MWO 9-2320-280-20-4

MODIFICATION WORK ORDER

MODIFICATION OF 1-1/4 TON VEHICLES M998 SERIES STEERING COLUMN INSPECTION AND BRACKET INSTALLATION

15 April 1996

FIGURE 1

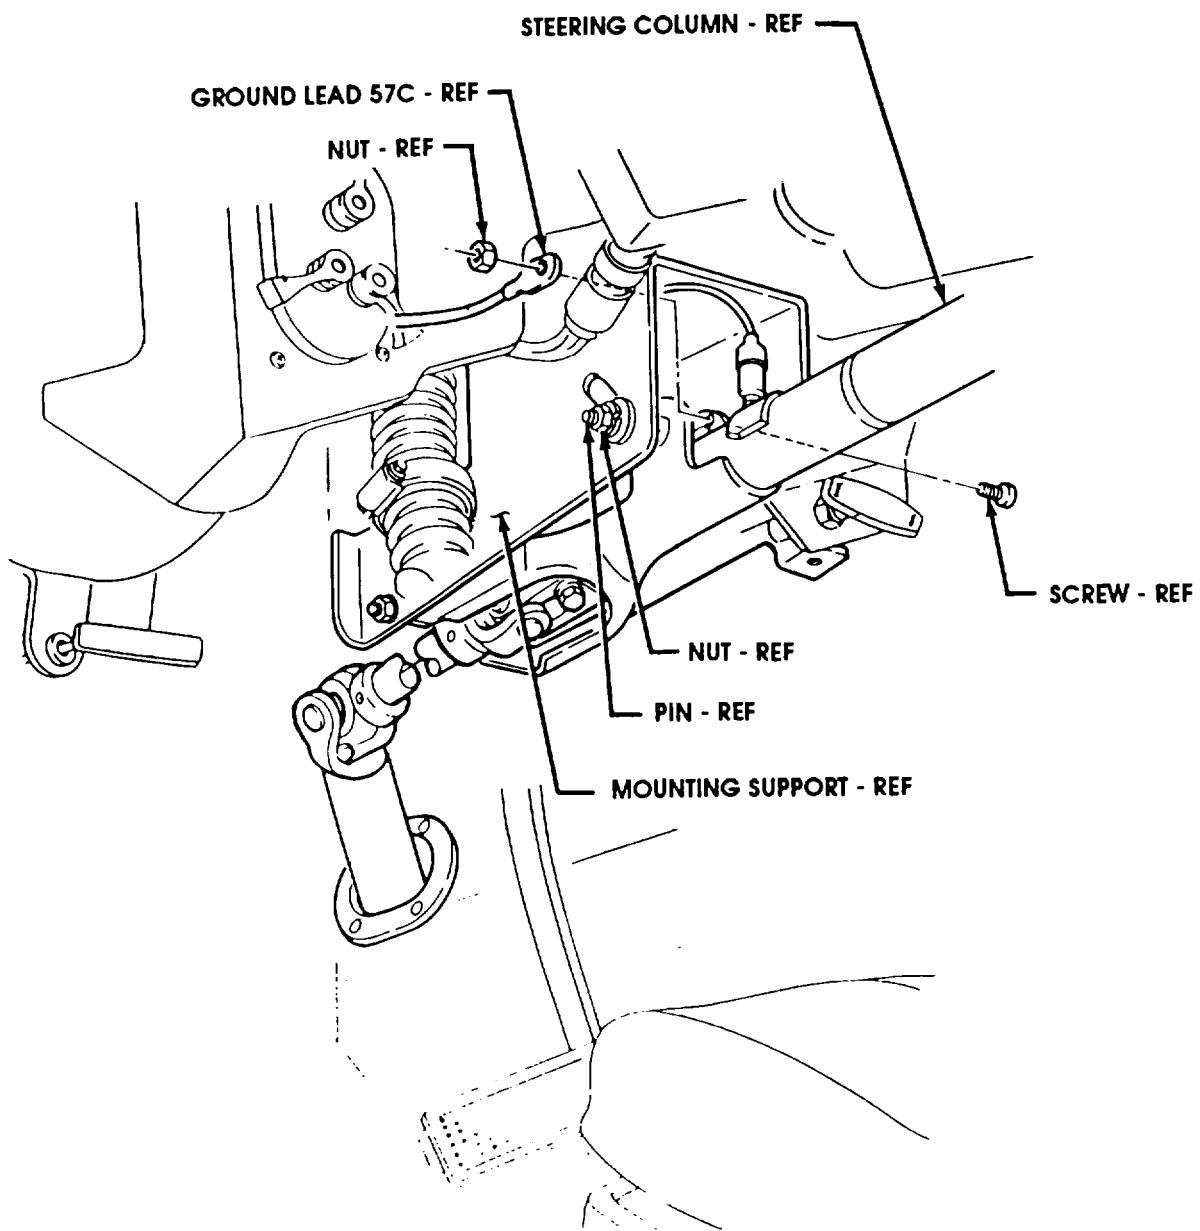
- a. VEHICLE PREPARATION.
 - (1) Apply parking brake. (Refer to TM 9-2320-280-10.)
 - (2) If installed, remove driver's side front door. (Refer to TM 9-2320-280-20.)
 - (3) Place driver's seat to the furthest rear position. (Refer to TM 9-2320-280-10.)
- b. STEERING COLUMN INSPECTION.
 - (1) Loosen nut on pin and place steering column in down position on mounting support as shown in figure 1.

- **If mushrooming is not present, perform step "4".**
- c. STEERING COLUMN BRACKET INSTALLATION.
 - (1) Remove screw, nut, and ground lead 57C from steering column as shown in figure 1.

FIGURE 2

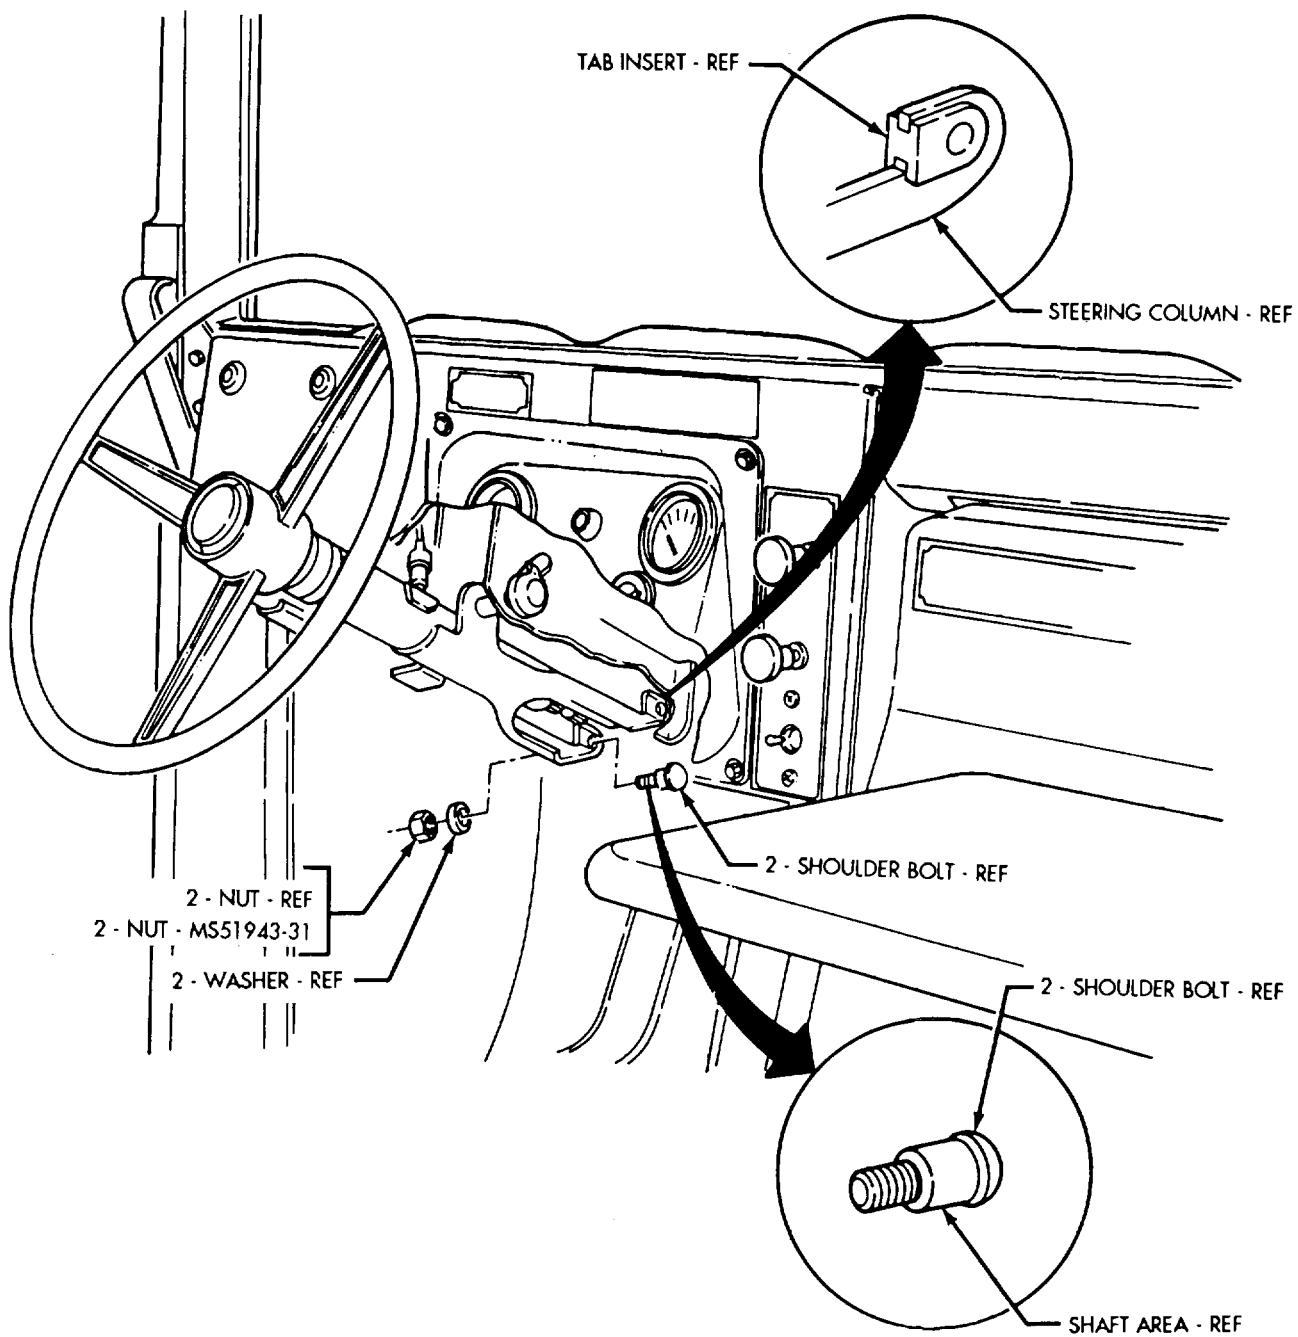
- (2) Remove two shoulder bolts, washers, and nuts from steering column as shown in figure 2.
- (3) Check tab inserts at end of steering column for paint and metal cracking as shown in figure 2. If cracking is present on or around tab inserts, discontinue inspection procedure and replace steering column (Refer to TM 9-2320-280-20).

- **Check shoulder bolts removed in step "2" for "mushrooming" around shaft area of shoulder bolt as shown in figure 2. If mushrooming is present, replace shoulder bolts, washers, and nuts (Refer to TM 9-2320-280-20).**

FIGURE 3

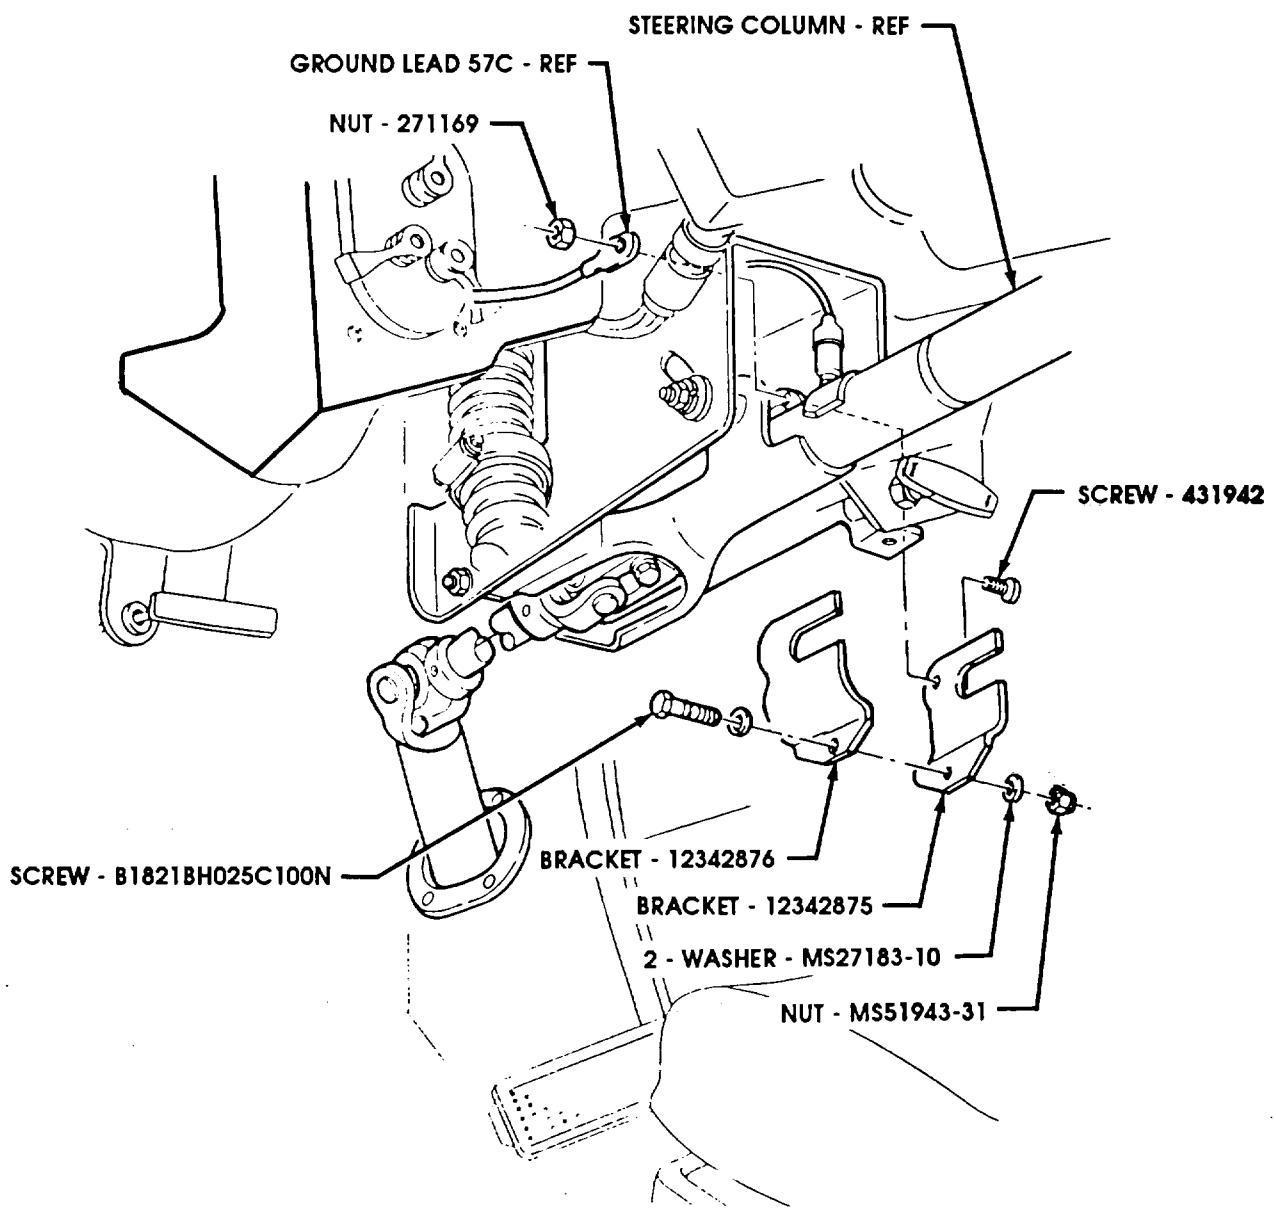
- (2) Secure ground lead 57C and 12342875 bracket to steering column with 431942 screw and 271169 nut as shown in figure 3. Do not tighten nut.
 - (3) Secure 12342876 bracket to bracket (12342875) and steering column with B1821BH025C1OON screw, two MS27183-10 washers, and MS51943-31 nut as shown in figure 3. Tighten nut to 10 lb-ft (14 N•m).

- (4) Tighten nut (271169) installed in step "2" as shown in figure 3.
 - (5) Place steering column and pin in upward position on mounting support until steering column cannot be raised any further as shown in figure 5. Tighten nut on pin to 14 lb-ft (19 N•m).

FIGURE 4

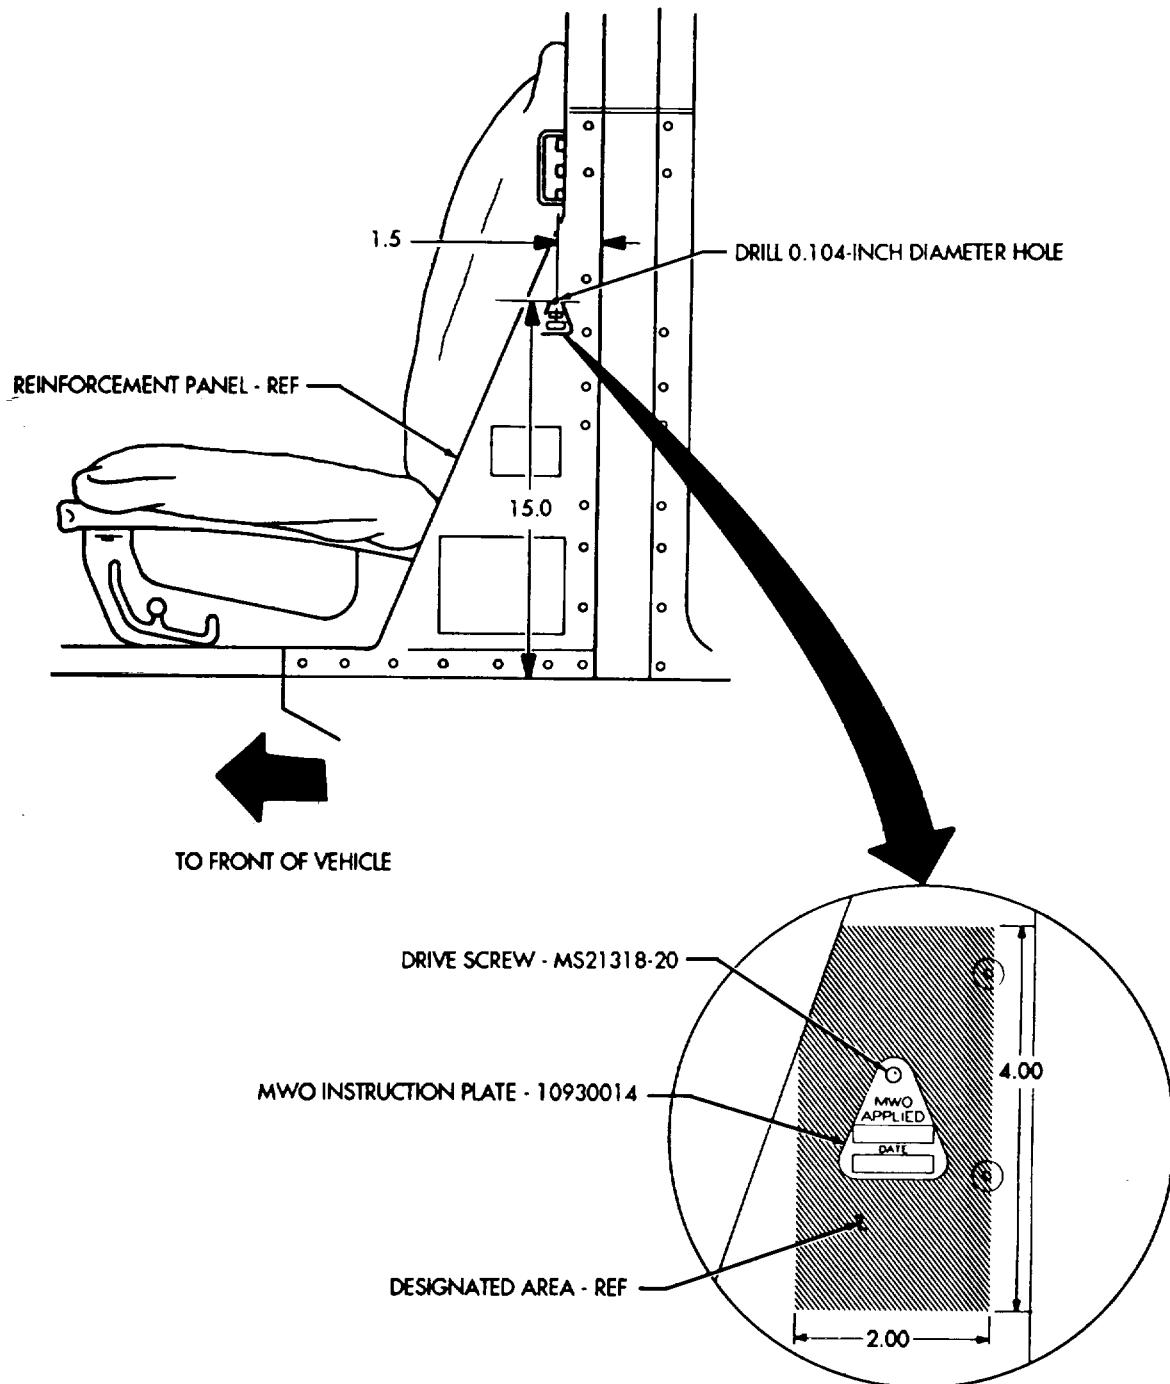
(2) Install 10930014 MWO instruction plate by drilling a 0.104-inch diameter hole within designated area on body reinforcement panel and secure with MS21318-20 drive screw as shown in figure 4.

FIGURE 5

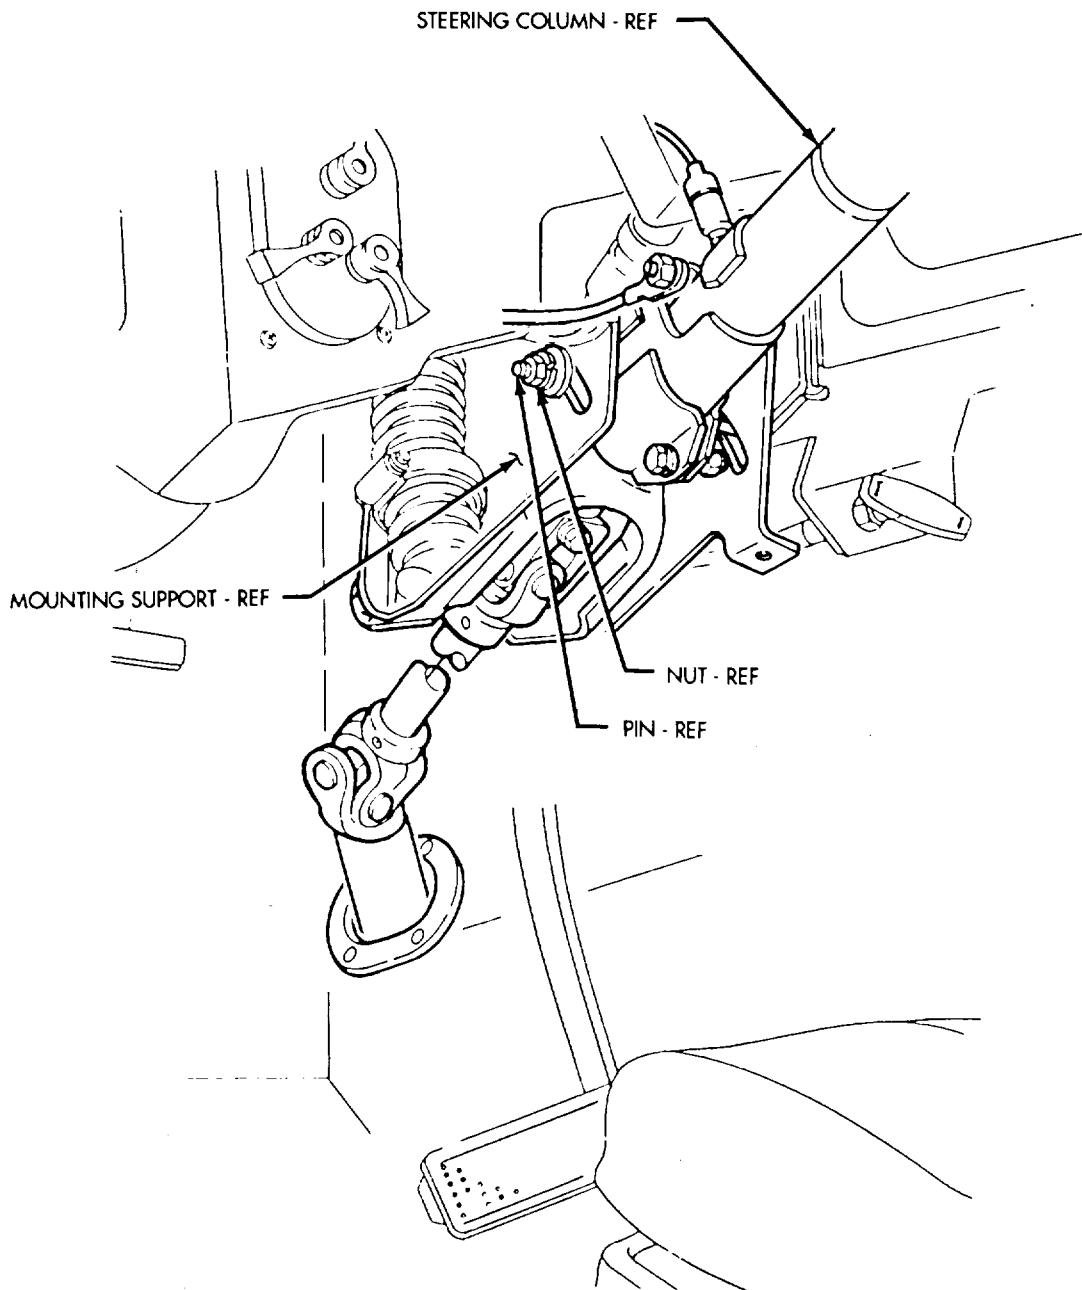
a. When installed correctly, the steering column brackets will appear as shown in figure 5.
